Technical change to TBY interfaces

PCN-number: 20210602

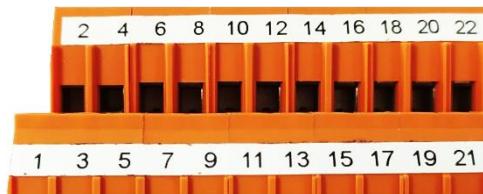
Articles on Section 5 were delivered in the past with LP2N connectors. Furthermore, they were delivered with Dekafix*

Based on continuous improvement the LP2N connectors will be replaced by LL2N connectors with KSW strip markers.

Old version	Matting compatibility	New version
LP2N 5.0x		LL2N 5.0x/90
